Drainage Technical Note 01 (to discharge Planning Condition 10)

Sytner Group Porsche, Mid Sussex, London Road, Sayers
Common, Hassocks BN6 9HS

Project Number	Document Reference	Revision
23-0466	230466-ROL-ZZ-XX-RP-C-0001	S2-P01

This Technical note has been prepared to discharge planning condition 10 for the proposed new Porsche dealership at London Road, Sayers Common, Hassocks BN6 9HS as identified on Lead Local Flood Authorities (LLFA) review letter ref. 'P269 UPDATED FILE NOTE 4th July 2025, recreated as follows;

Drawing Title:
**Existing Drainage
General Arrangement Plan**

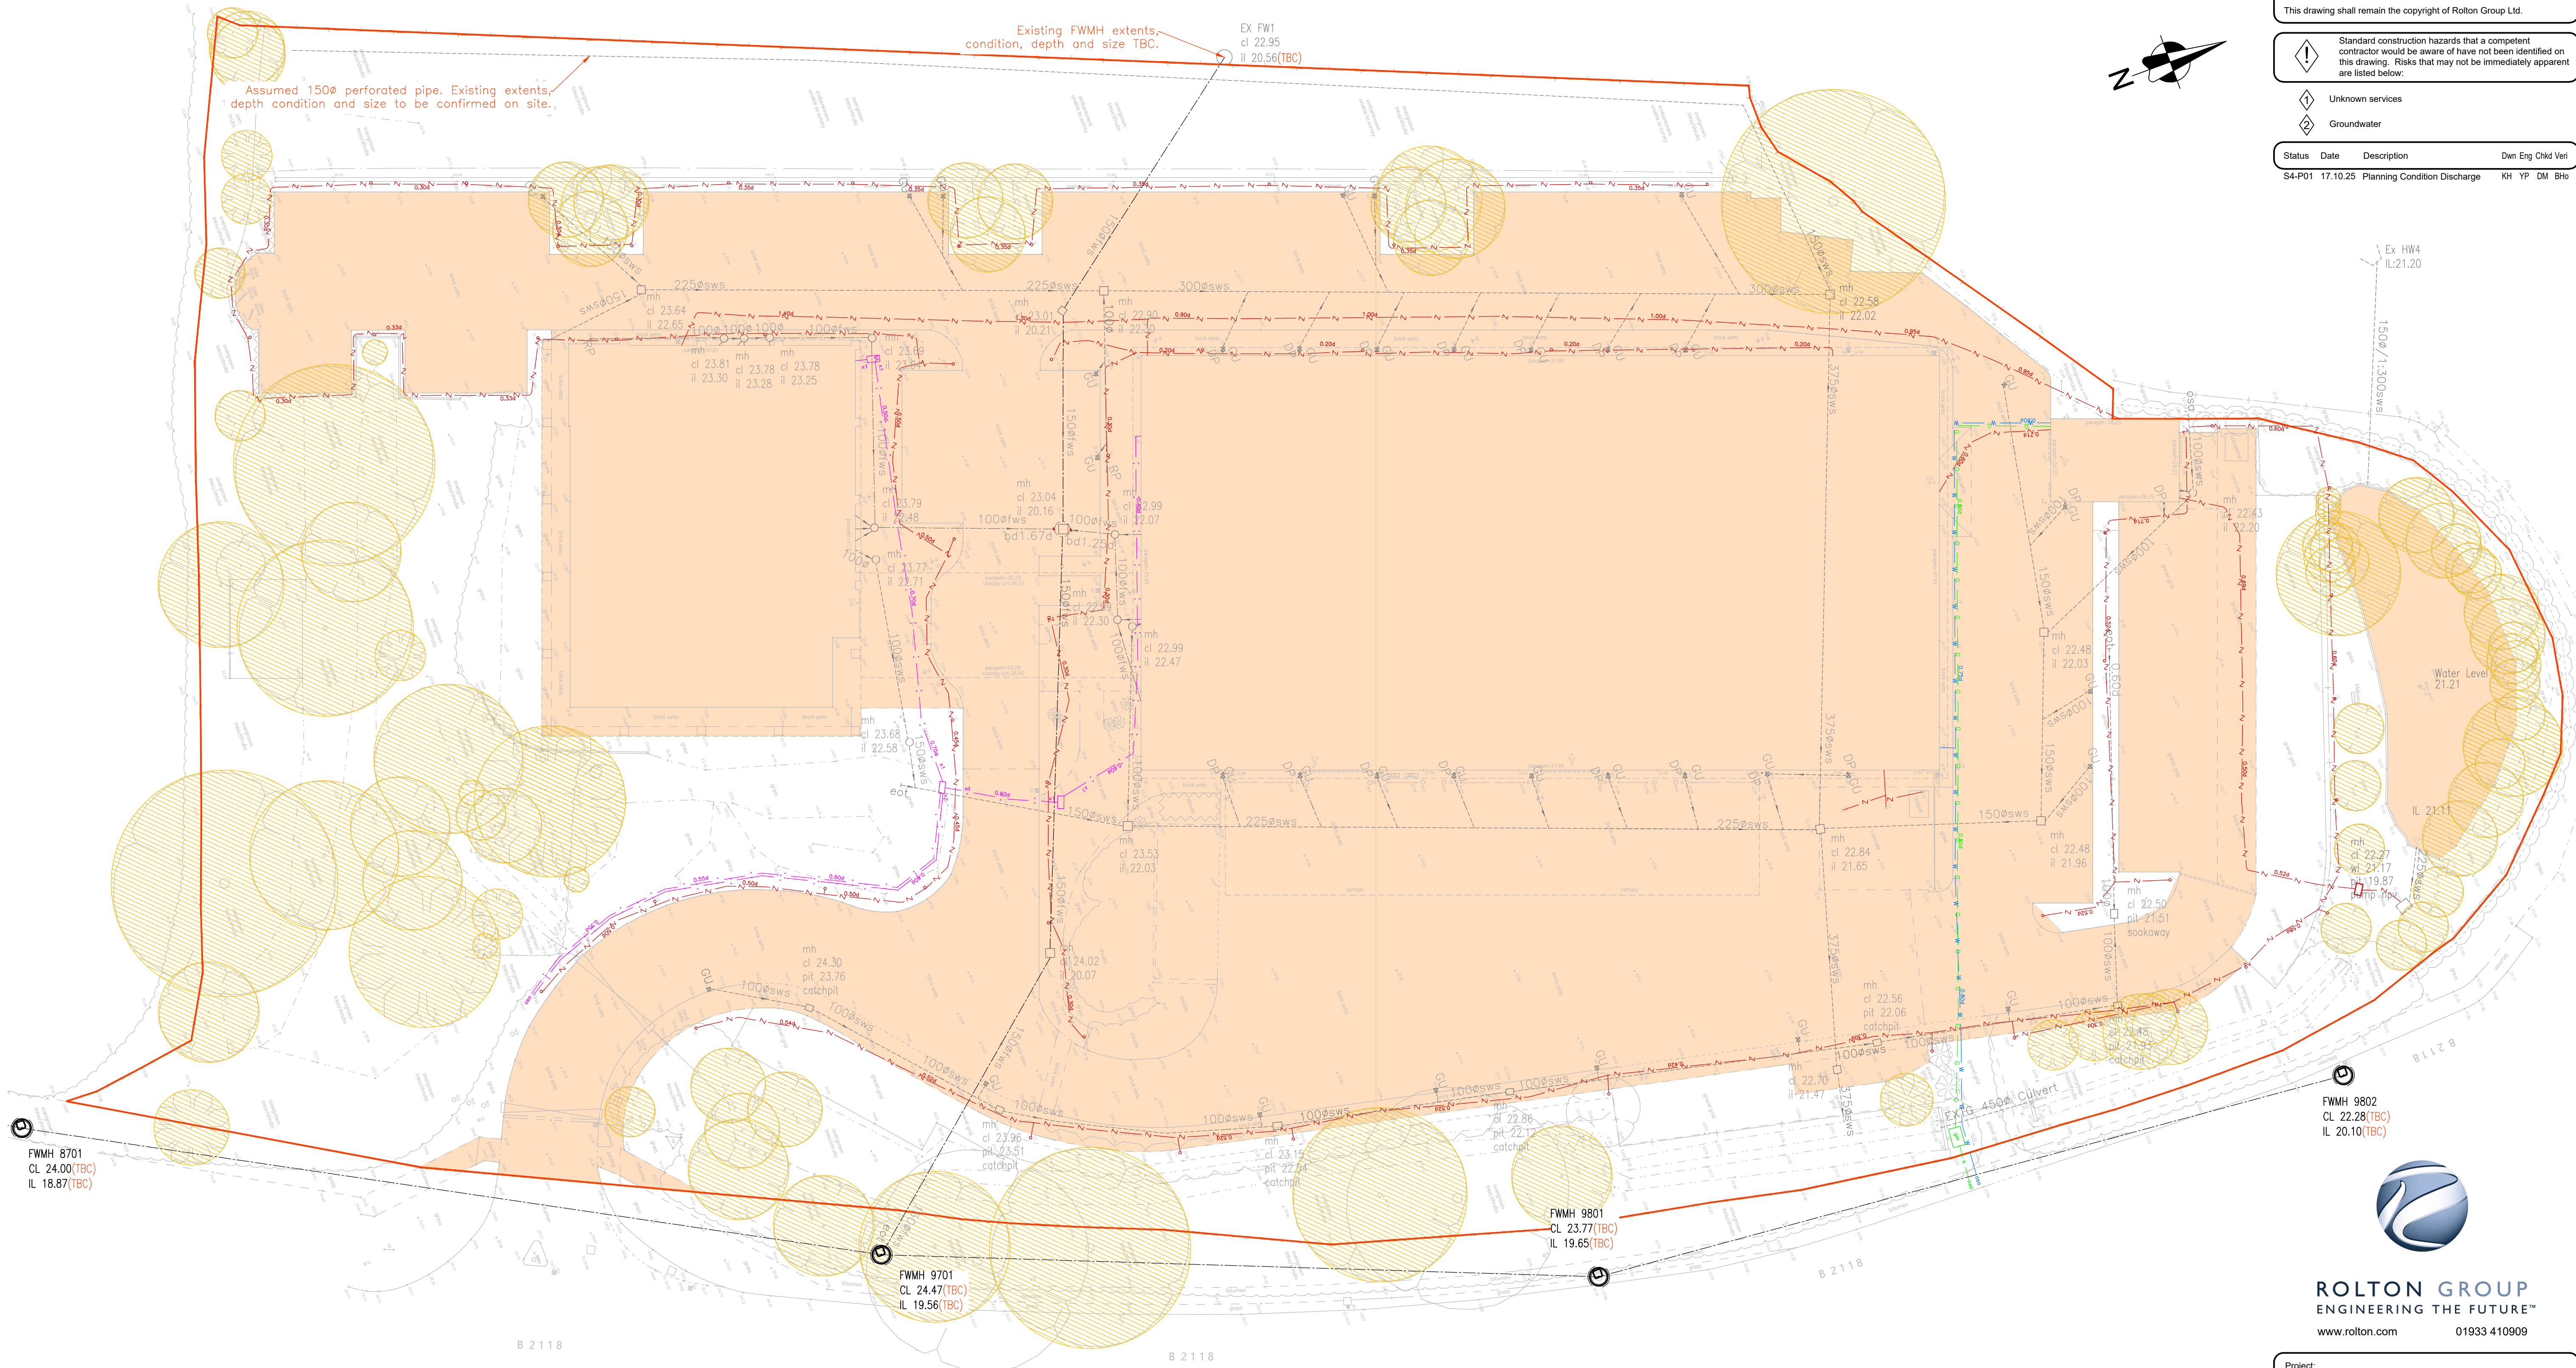
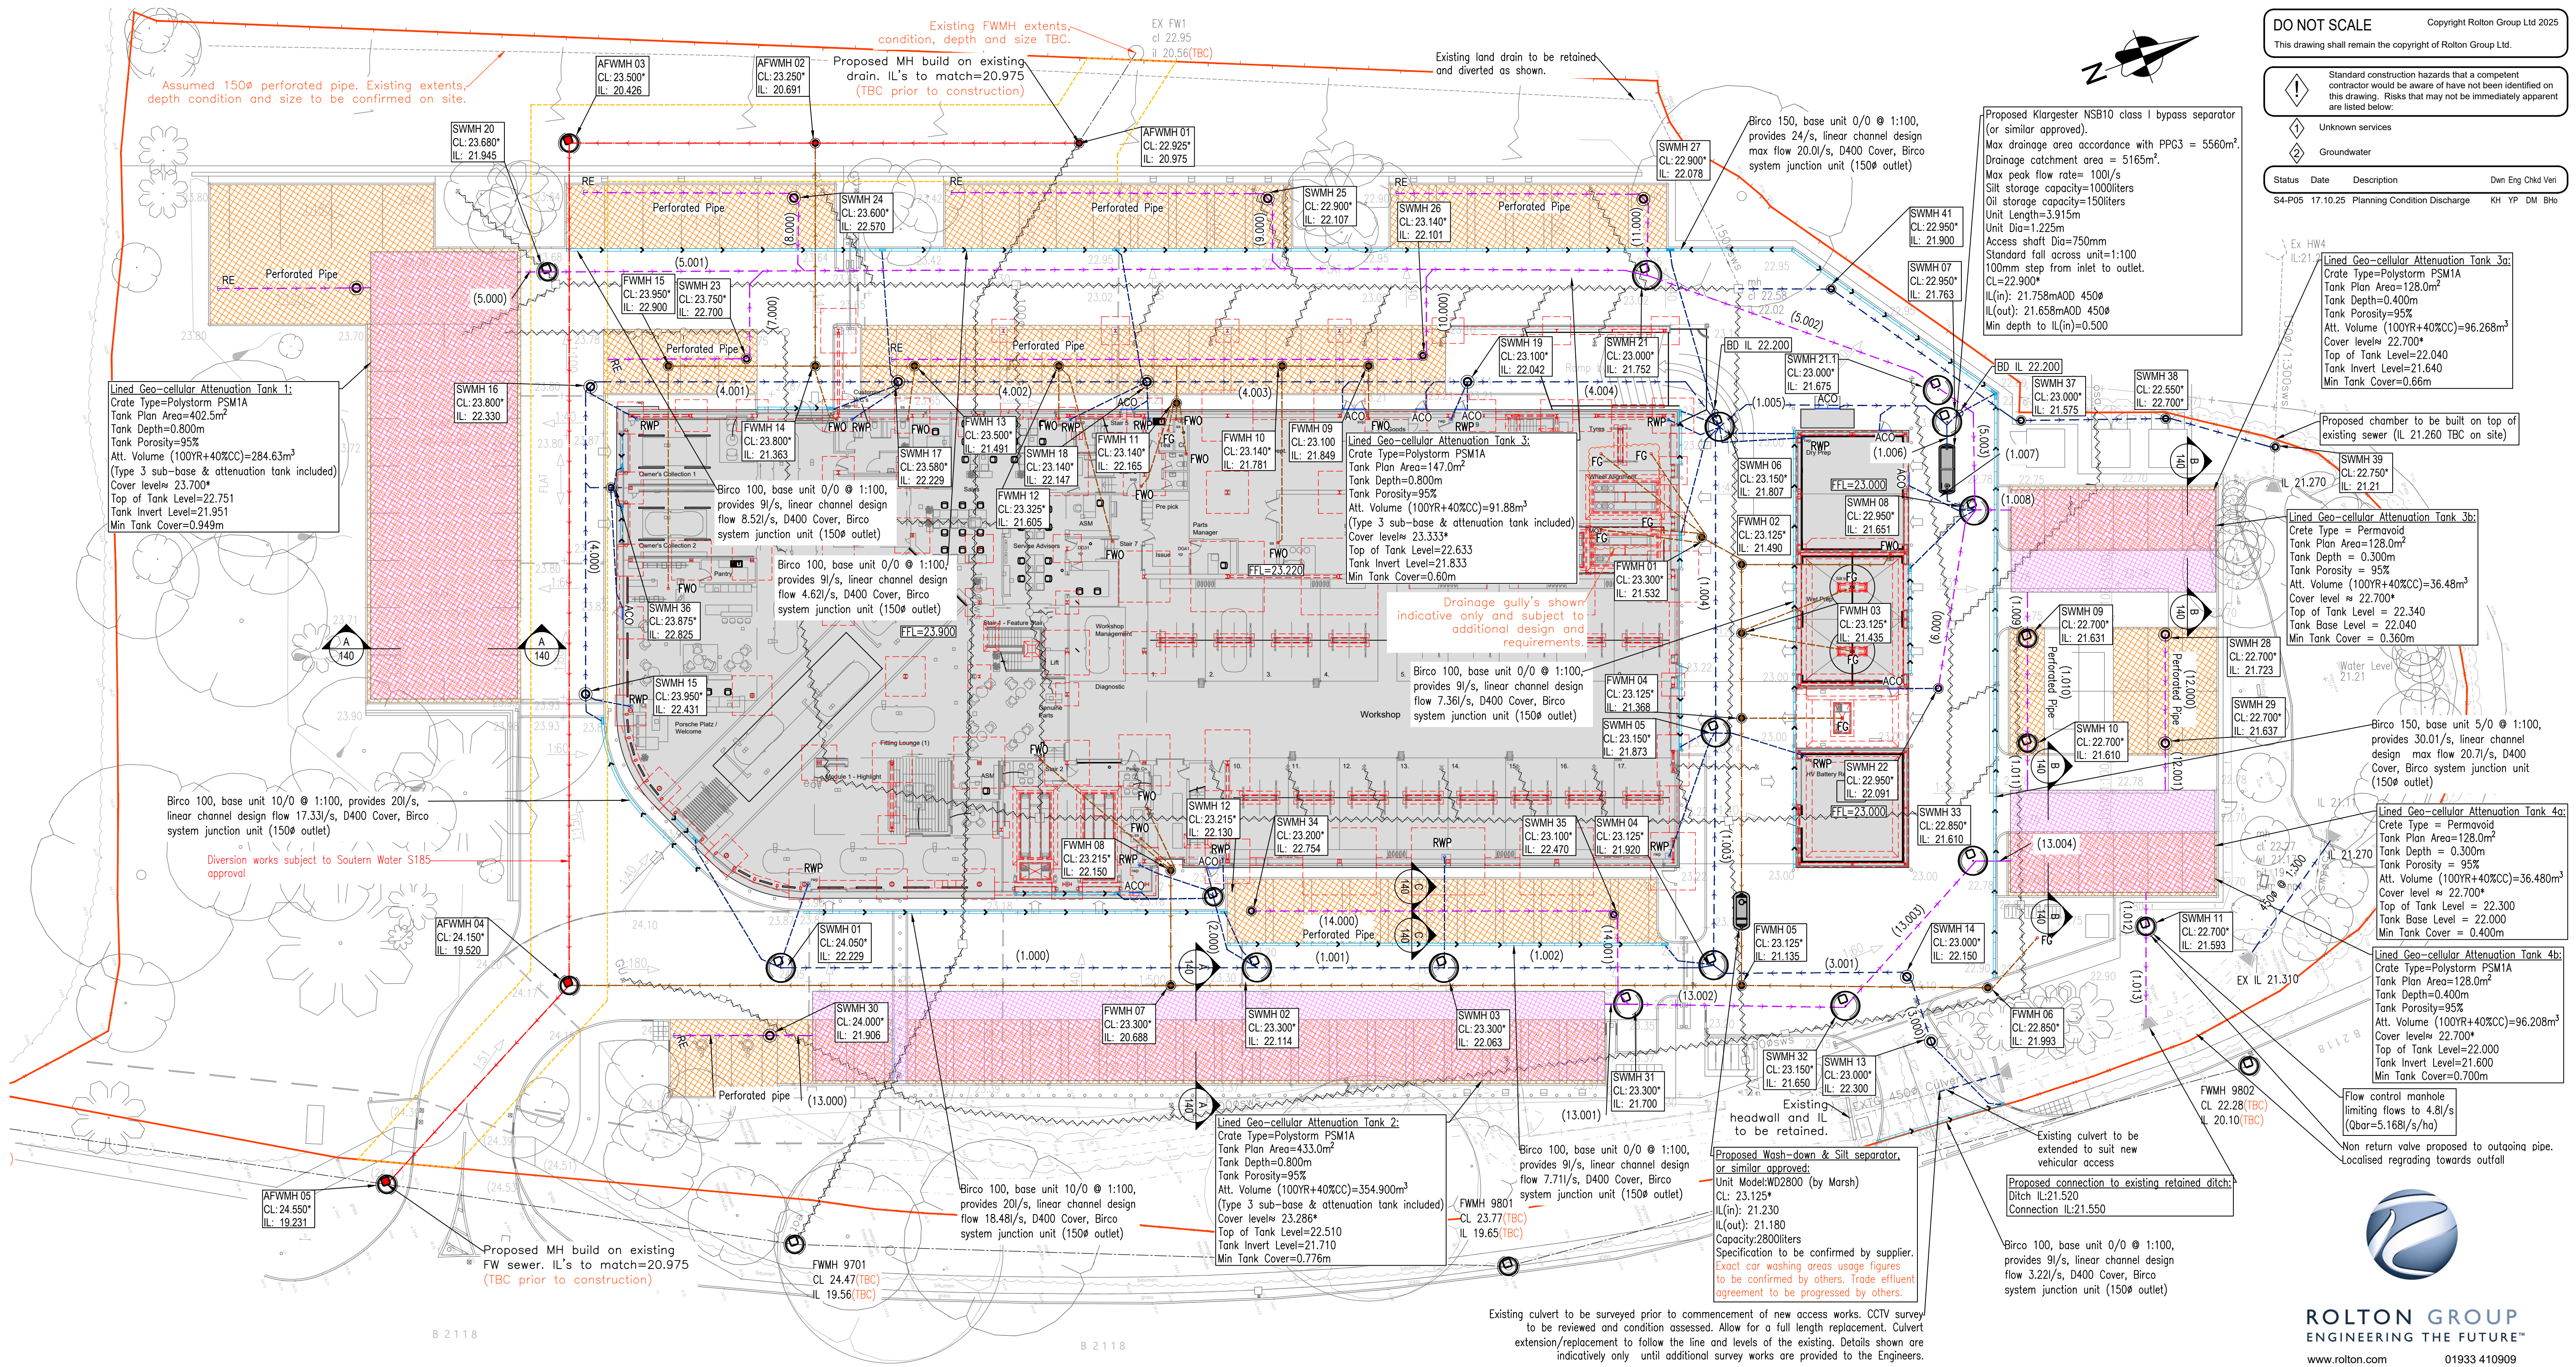
- Reviewer's comments:
It should be demonstrated that the existing outfall pipework being retained is adequately sized for both the discharge from the land drain and the pond
- Response:
An existing flowrate of 367 l/s has been calculated for the existing development for the 1 in 100 storm, following the Modified Rational Method discharge via the existing outfall pipework.

Existing flowrate for the 1 in 100 storm: 367 l/s (Based on Modified Rational Method)
